APPROACH SLAB #2 PLAN

CONTRACTOR: VTAOT STOWE BRF 0235(11)
LIGHTING:
ARCHITECT:
ENGINEER:
OWNER: SD IRELAND CONCRETE CONST. CORP.
DRAWN BY: ED
DATE: 12/2/14
DFI #: 9117
DRAWING CONTENT: APPROACH SLAB #2 DUAL COATED REINFORCING
DRAWING #: B

Vermont Agency of Transportation
RECEIVED
CK'D BY CLB OK'D BY DRP
January 13, 2015
RESUBMIT NO Approved AsNoted
BY C. CARLSON DATE 01/15/15

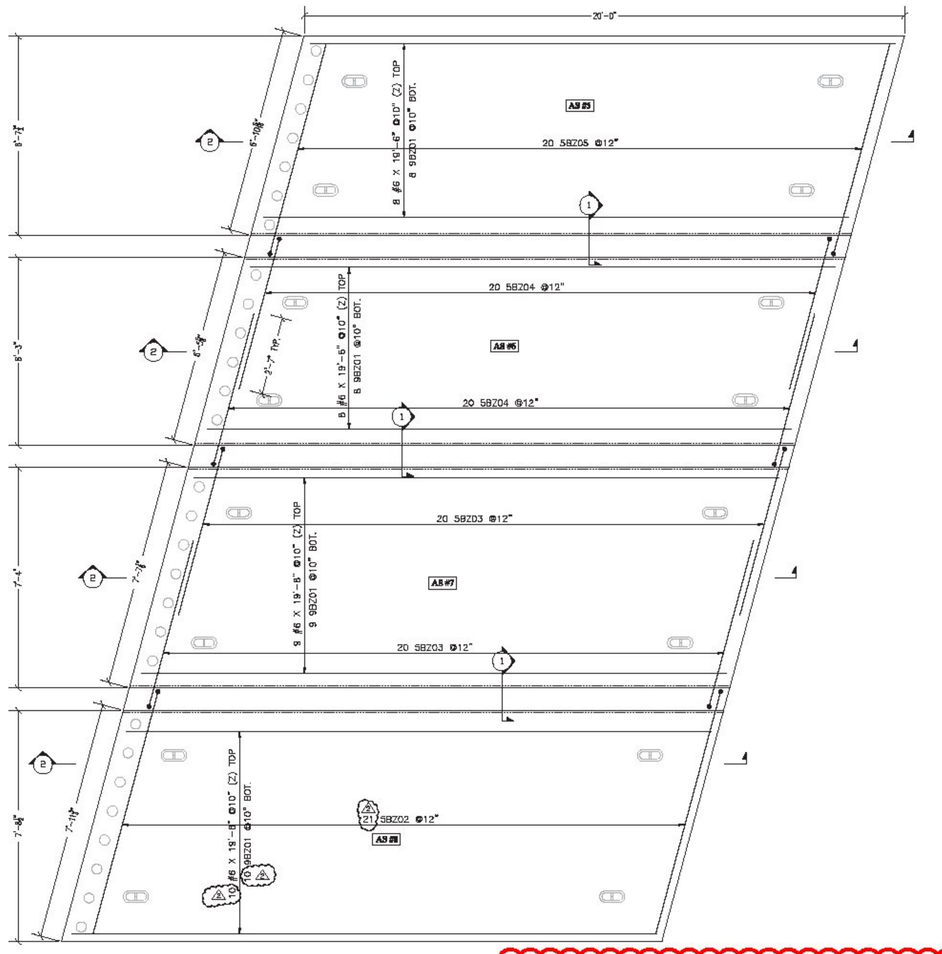
Okay that CCS is providing additional bars in the closure pour but it should be understood that these bars are incidental to the approach slab bid item.

Agree must provide two, 5-foot test bars per each bar size. Just make sure it is understood that the quantities at the top of this sheet do not account for the test bars.

Fine
